HITACHI SEMICONDUCTOR TECHNICAL UPDATE

Classification of Production	Development Environment			No	TN-OS*-058A/E		
ТНЕМЕ	HI7700/4 V1.1.00 Revision up		Classification of Information	2. Spec chang 2. Supplement Documents 3. Limitation of	of	_	of Mask of Production Line
	HOOGGOITHAIGDE	Lot No.				Rev.	Effective Date
PRODUCT NAME	HS0770ITI41SRE, HS0770ITI41SRB, HS0770ITI41SRS, HS0770ITI41SRE-E, HS0770ITI41SRB-E, HS0770ITI41SRS-E	V1.00r1, V1.01r1, V1.0Ar1, V1.0Br1, V1.0Cr1	Documents	HI7000/4 Serie Manual(ADE-7		Rev.1	Forever

We release HI7700/4 V1.1.00.

HI7000/4 series User's Manual supplemental information (Rev.4)

Figure 2.10 Example of Using a Message Buffer

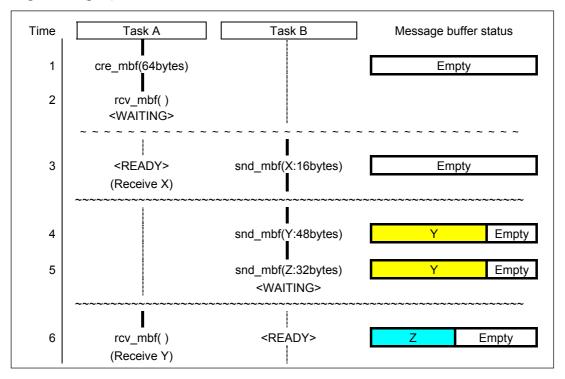
2.1 Figure 2.10 (p.29)

Description:

Bold lines represent executed process. The following describes the message buffer operation with respect to time.

- 1. Task A creates a 64-byte message buffer, which deals the message where the maximum size is 48 bytes, by issuing cre mbf.
- 2. Task A receives a message by preparing the 48-byte memory and issuing rcv_mbf. Task A is placed in the WAITING state since there are no messages in the message buffer.

- 3. Task B sends a 16-byte message X by issuing snd_mbf. At this time, task A is released from the WAITING state and message X is copied to the memory prepared by task A. Task A receives message size 16 as the return parameter.

- 4. Task B sends a 48-byte message Y by issuing snd_mbf. At this time, since there are no tasks waiting for a message, message Y is copied to the message buffer. In this case, the kernel uses 4-byte message buffer area to copy message Y to the message buffer, however this is not indicated in figure 2.10.

- 5. Task B attempts to send 32-byte message Z by issuing snd_mbf. At this time, since the message buffer is not large enough to store message Z, task B is placed in the WAITING state.

- 6. Task A prepares the 48-byte memory and issues rcv_mbf to receive a message, 48-byte message Y stored in the message buffer is copied to the memory prepared by task A. Task A receives message size 48 as the return parameter. At this time, since the message buffer has sufficient space to store message Z, task B is released from the WAITING state and message Z is copied to the message buffer.
